California MLPA Master Plan Science Advisory Team
Draft Summary of SAT Water and Sediment Quality Evaluation of Round 2
MPA Proposals for the MLPA South Coast Study Region
June 16, 2009 Draft

Overview of MPA Proposal Evaluations Regarding Water and Sediment Quality

Figure 1. Scores for all water quality evaluation categories in a given proposal.

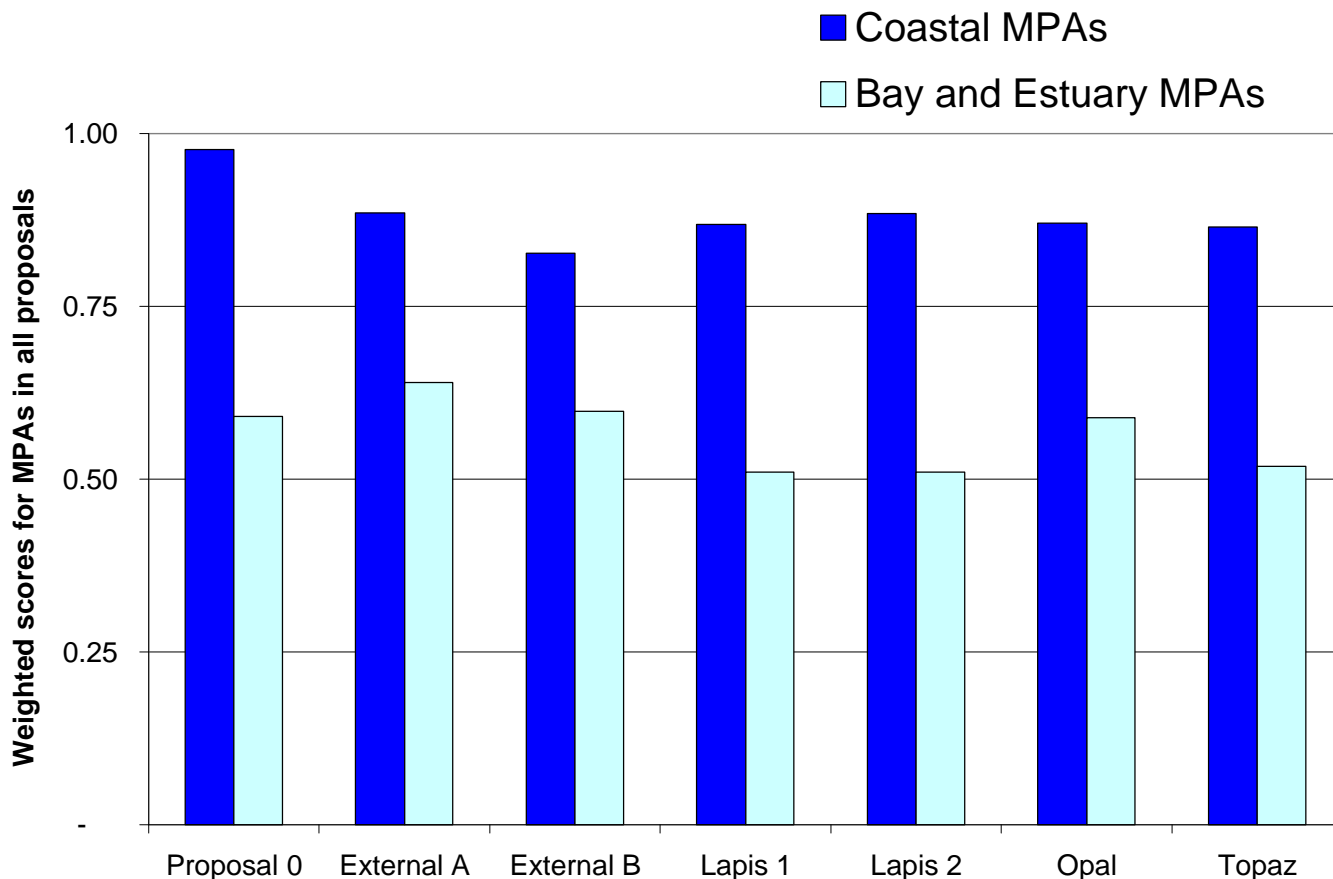
In the water quality evaluation, all proposed coastal MPAs scored very well. However, the bay and estuary MPAs scored poorly, although this was expected (Figure 1). Of the six proposal submitted for evaluation, External A and Lapis 2 had the most favorable coastal MPAs scores while External B had the least favorable coastal MPA scores. The difference between the high and low scores was very small. The inclusion of the Northern Channel Islands MPAs helped to improve all the proposals weighted score due to the presence of large ASBSs at the islands.

There were two power plant intakes zones that influenced nearly all of the proposal's scores for the bay and estuary MPAs; 1) Encina Power Plant near Agua Hedionda Lagoon and 2) the South Bay Power Plant in San Diego Bay. Only one proposal, External A, avoided all power plant intake zones. Most proposals did a fairly good job of avoiding municipal or industrial wastewater zones with the exception of External B which scored the lowest in the municipal and industrial wastewater category. Areas where wastewater discharge zones were included in the MPA proposals include the Palos Verdes Peninsula and Dana Point. Proposal 0 scored higher than all new proposals; this could be contributed to the very small size of MPAs that had water quality concerns. All proposals had some water quality concerns within their coastal MPAs and bay and estuary MPAs.

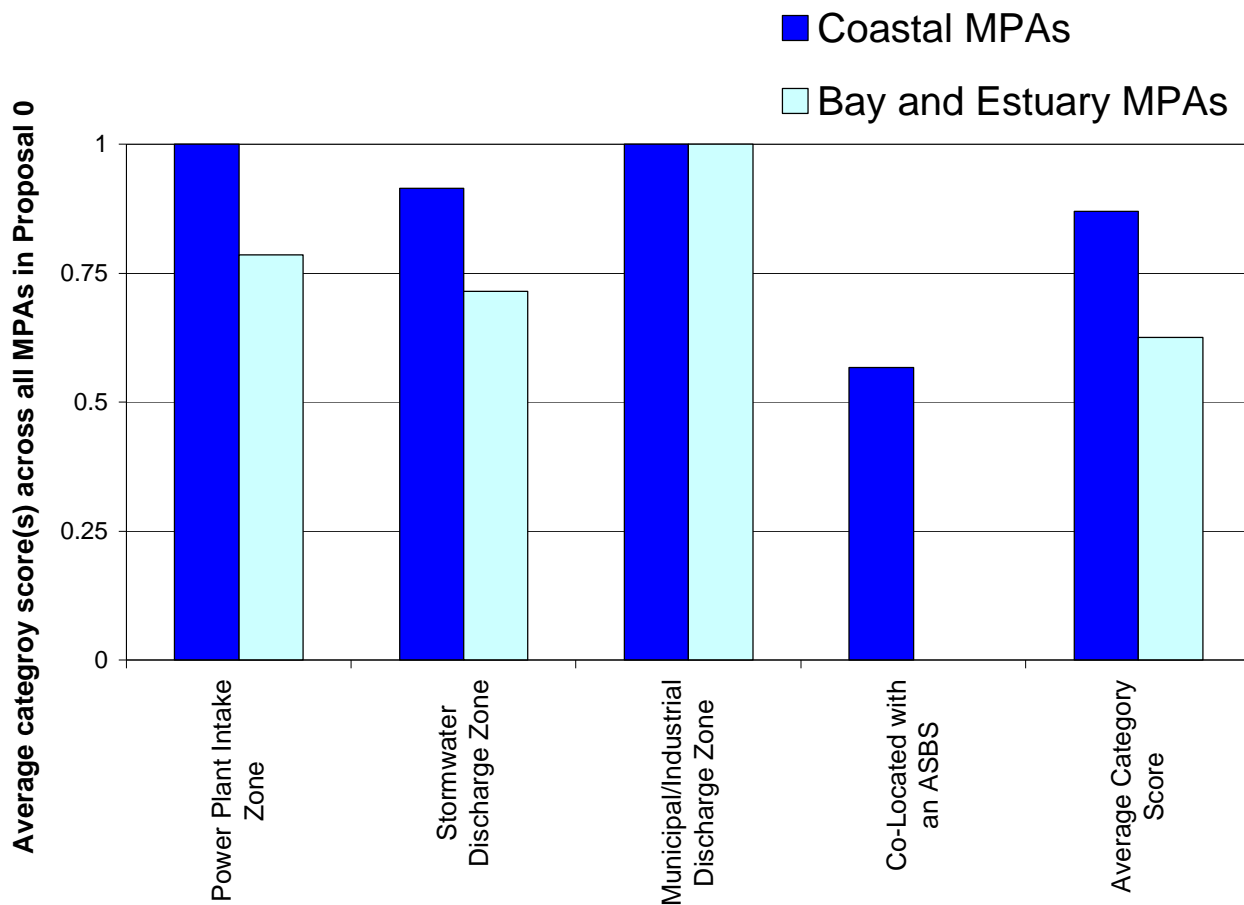
Proposal 0 (the existing MPAs) contains 42 MPAs. There are 35 MPAs located along the coast and seven located in bays and estuaries. Three coastal MPAs scored lower than 0.75 (all located within stormwater discharge zones), while there were 32 coastal MPAs which scored between 0.75 and 1.0, the threshold at which MPAs do not contain water quality concerns. Three MPAs located in bays and estuaries scored lower 0.75 while the remainder scored exactly 0.75. (Table 1, Appendix A). There is one existing MPA co-located in a bay with a power plant intake and two located in lagoons connected to major stormwater discharge zones. The existing MPAs have 21 MPAs co-located within ASBSs (Table 1), 13 of which are located at the Northern Channel Islands. It is also important to note that through out all proposals, the existing Channel Islands MPAs all are co-located within ASBSs which helped the overall score of each proposal.

Figure 3. Scores for all water quality evaluation categories for External A. Scores between 0.75 and 1.0 indicate MPA placement without water quality concern area. Scores less than 0.75 indicated placement of MPAs within water quality concern areas. See appendix B for the breakdown of these scores.

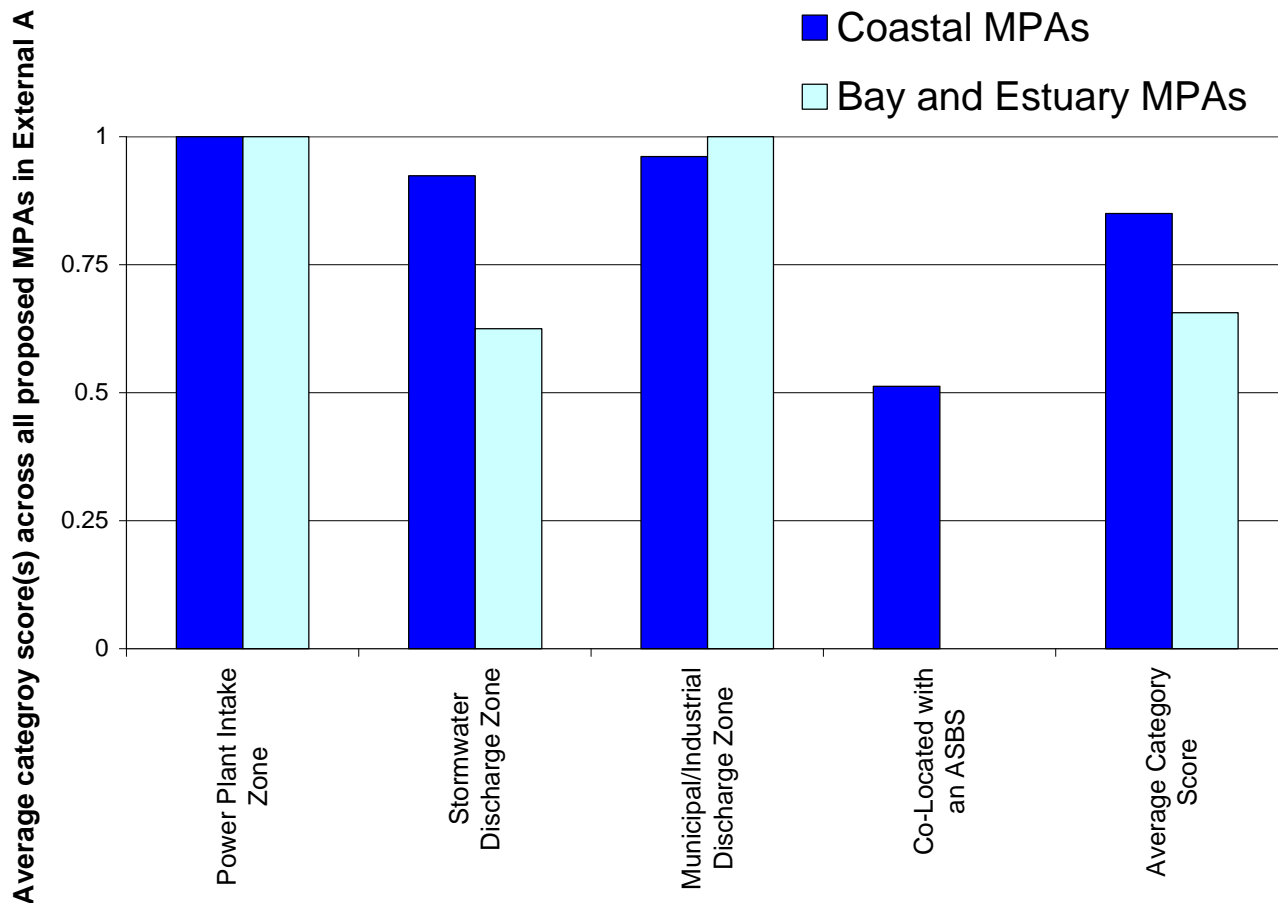
The External A proposal has 47 MPAs, 13 of which came from the already existing Northern Channel Islands MPAs, which were included by all proposals. There were five coastal MPAs with scores lower than 0.75 and three MPAs located in lagoons that had scores lower than 0.75. There were 38 MPAs in the entire proposal which scored between 0.75 and 1.0, the threshold at which MPAs do not contain water quality concern areas (Table 2, Appendix B). The coastal MPAs received reduced scores because they were located within wastewater discharge zones. (Figure 1). This proposal was improved by co-locating 20 MPAs within ASBSs (Table 2). It is also important to note that through out all proposals, the 13 existing Channel Islands MPAs all are co-located within ASBSs which helped the overall score of each proposal.

Figure 4. Scores for all water quality evaluation categories for External B. Scores between 0.75 and 1.0 indicate MPA placement without water quality concern area. Scores less than 0.75 indicated placement of MPAs within water quality concern areas. See appendix B for the breakdown of these scores.

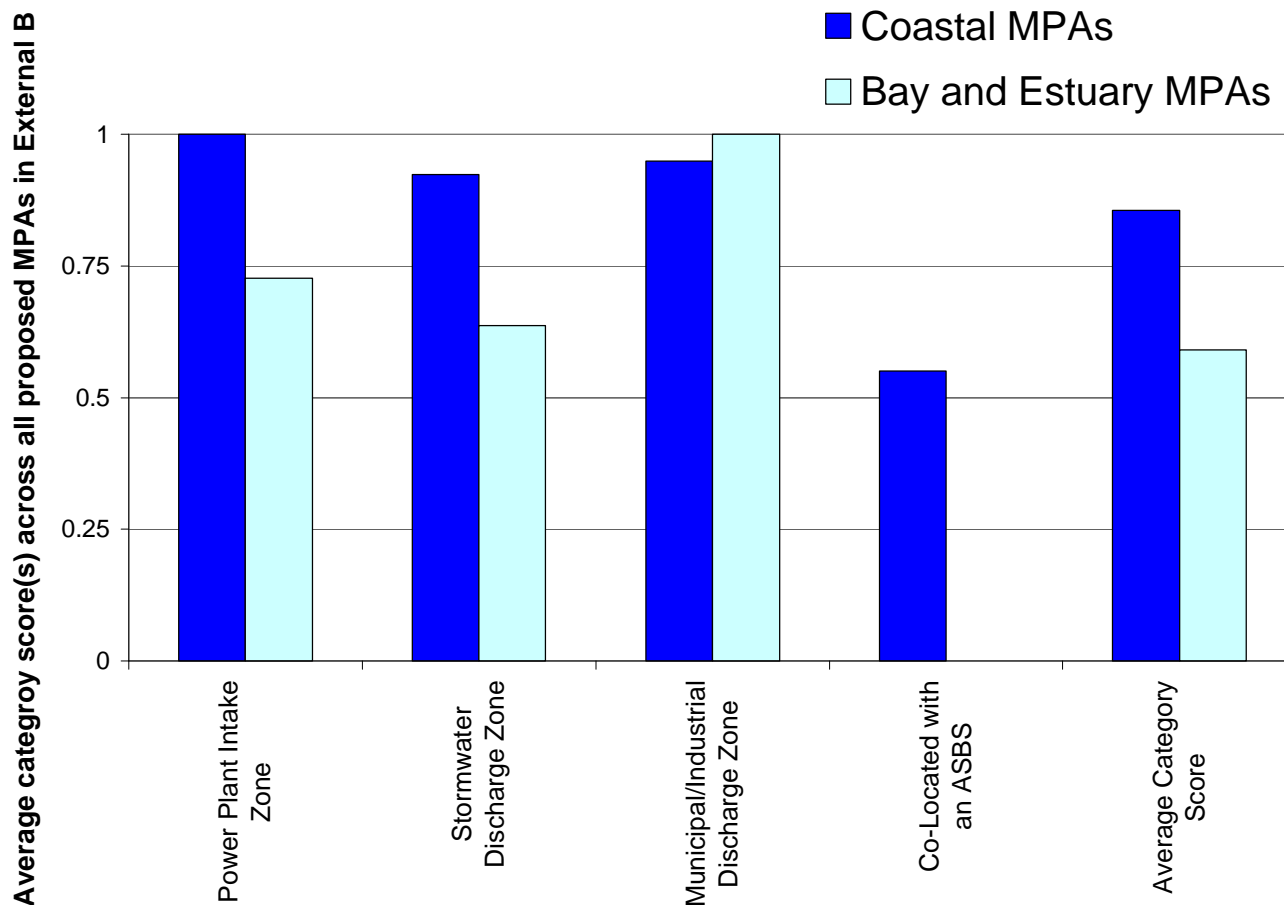
The External B proposal is comprised of 50 MPAs. There were six coastal MPAs which scored lower than 0.75, and five MPAs located in a bay or lagoon which scored lower than 0.75. There were 38 MPAs which scored between 0.75 and 1.0, the threshold at which MPAs do not contain water quality concern areas (Table 3, Appendix C). This proposal had one MPA placed in the San Diego Bay (scored 0.13), which was identified by the SAT as an undesirable location for MPA placement in the SCSR because they contain water quality conditions that will most likely compromise MPA performance and potentially the ability of an MPA to meet the goals of the MLPA. The coastal MPAs received reduced scores because they were located within wastewater discharge zones and stormwater discharge zones. However, the score of this proposal was improved by having 24 MPAs located within ASBSs (Table 3).

Figure 5. Scores for all water quality evaluation categories for Lapis 1. Scores between 0.75 and 1.0 indicate MPA placement without water quality concern area. Scores less than 0.75 indicated placement of MPAs within water quality concern areas. See appendix B for the breakdown of these scores.

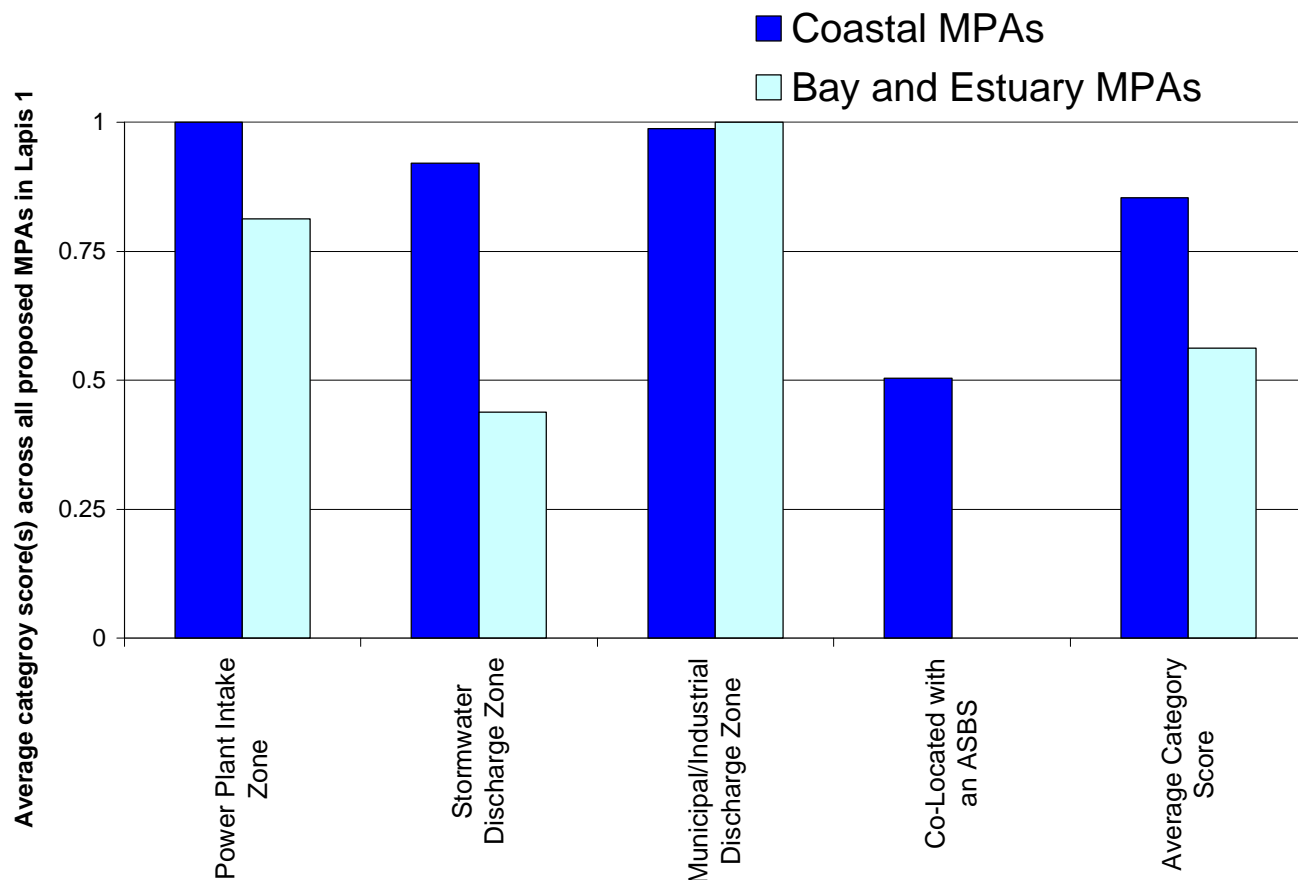
The Lapis 1 proposal is comprised of 54 MPAs. There were three coastal MPAs and ten MPAs (located in a bay or estuary) which scored lower than 0.75, while there were 41 MPAs which scored between 0.75 and 1.0, the threshold at which MPAs do not contain water quality concern areas (Table 4, Appendix D). This proposal had one MPA placed in the San Diego Bay (scored 0.13), which was identified by the SAT as an undesirable location for MPA placement in the SCSR because they contain water quality conditions that will most likely compromise MPA performance and potentially the ability of an MPA to meet the goals of the MLPA. The Swamis-San Elijo SMCA also scored low (0.38) due to being located within both a stormwater discharge zone and a wastewater discharge zone (Figure 1). However, the score of this proposal was improved by having 22 MPAs located within ASBSs (Table 4).

Figure 6. Scores for all water quality evaluation categories for Lapis 2. Scores between 0.75 and 1.0 indicate MPA placement without water quality concern area. Scores less than 0.75 indicated placement of MPAs within water quality concern areas. See appendix B for the breakdown of these scores.

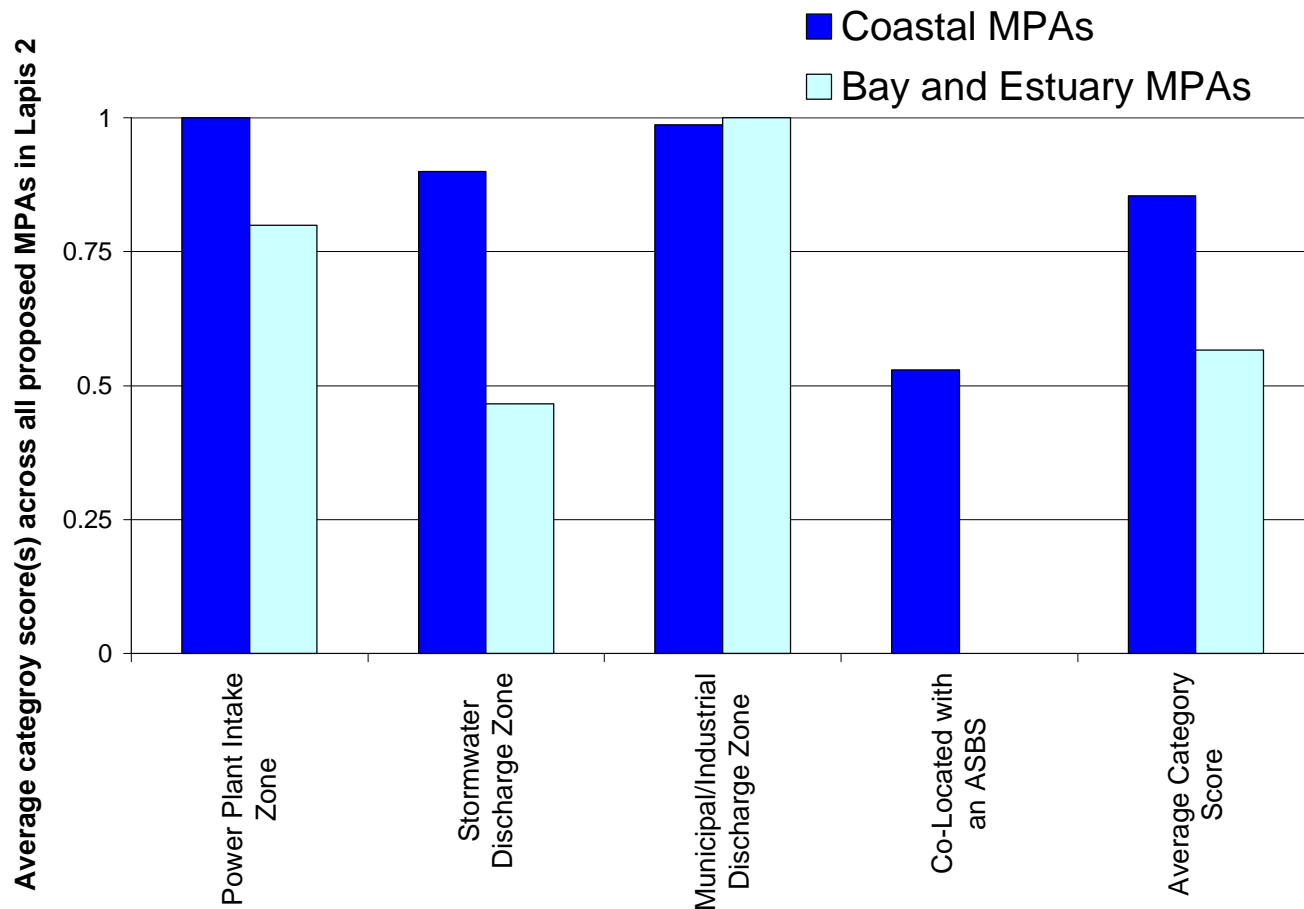
The Lapis 2 proposal is comprised of 55 MPAs. There were five coastal MPAs and nine bay and estuary MPAs which scored lower than 0.75, while there were 41 MPAs which scored between 0.75 and 1.0, the threshold at which MPAs do not contain water quality concern areas (Table 5, Appendix E). This proposal had one MPA placed in the San Diego Bay (scored 0.13), which was identified by the SAT as an undesirable location for MPA placement in the SCSR because they contain water quality conditions that will most likely compromise MPA performance and potentially the ability of an MPA to meet the goals of the MLPA. Overall, this proposal had four coastal MPAs located within stormwater discharge zones, one coastal MPA located in a municipal/industrial wastewater discharge zone and two bay and estuary MPAs located in power plant entrainment zones (Figure 1). However, the score of this proposal was improved by having 23 MPAs located within ASBSs (Table 5).

Figure 7. Scores for all water quality evaluation categories for Opal. Scores between 0.75 and 1.0 indicate MPA placement without water quality concern area. Scores less than 0.75 indicated placement of MPAs within water quality concern areas. See appendix B for the breakdown of these scores.

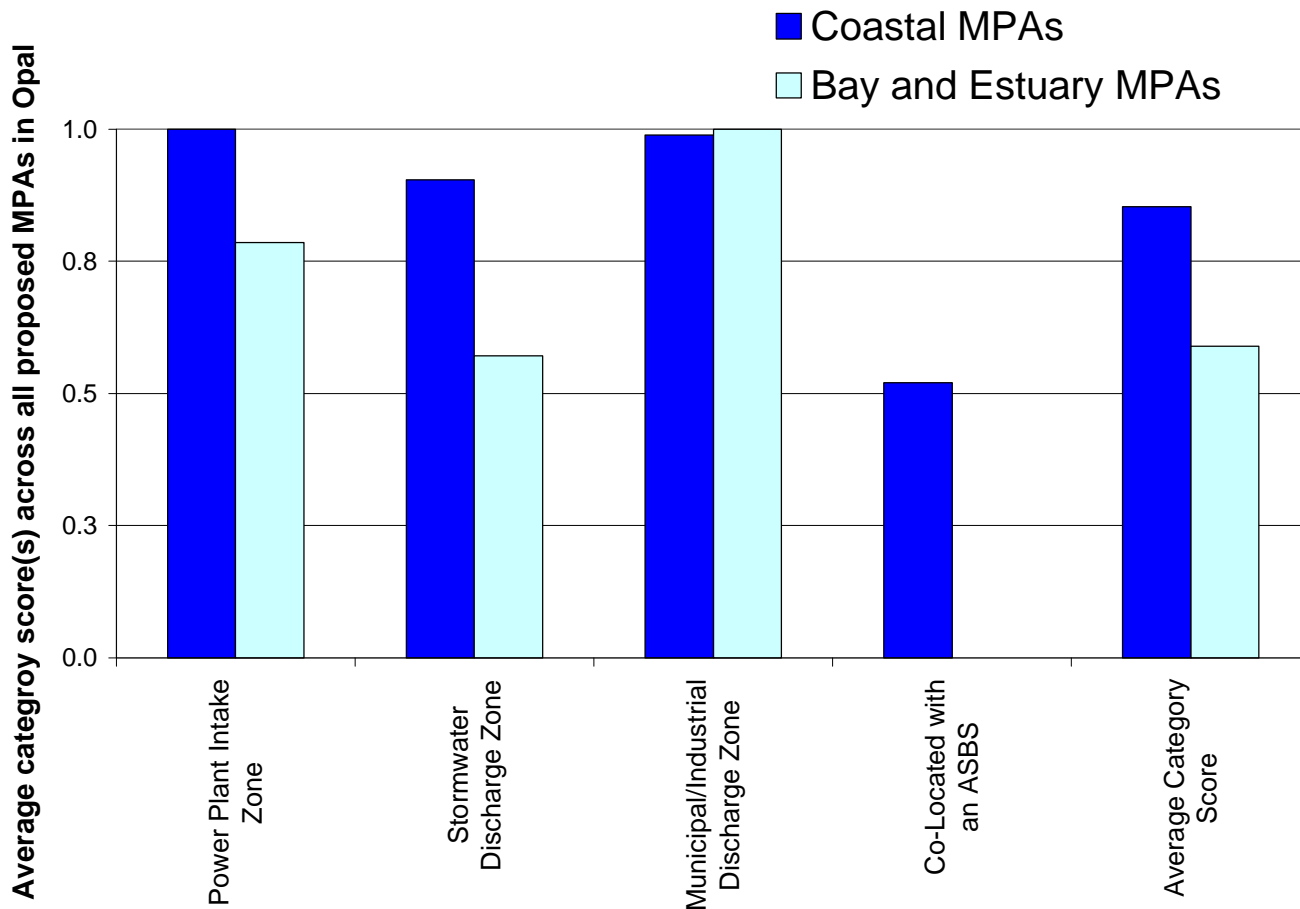
The Opal proposal is comprised of 56 MPAs. There were five coastal MPAs and six bay and estuary MPAs which scored lower than 0.75, while there were 44 MPAs which scored between 0.75 and 1.0, the threshold at which MPAs do not contain water quality concern areas (Table 6, Appendix F). This proposal had one MPA placed in the San Diego Bay (scored 0.13), which was identified by the SAT as an undesirable location for MPA placement in the SCSR because they contain water quality conditions that will most likely compromise MPA performance and potentially the ability of an MPA to meet the goals of the MLPA. The four coastal MPAs were located within stormwater discharge zones, and one coastal MPA was located within a wastewater discharge zone (Figure 1). However, the score of this proposal was improved by having 23 MPAs located within ASBSs (Table 6).
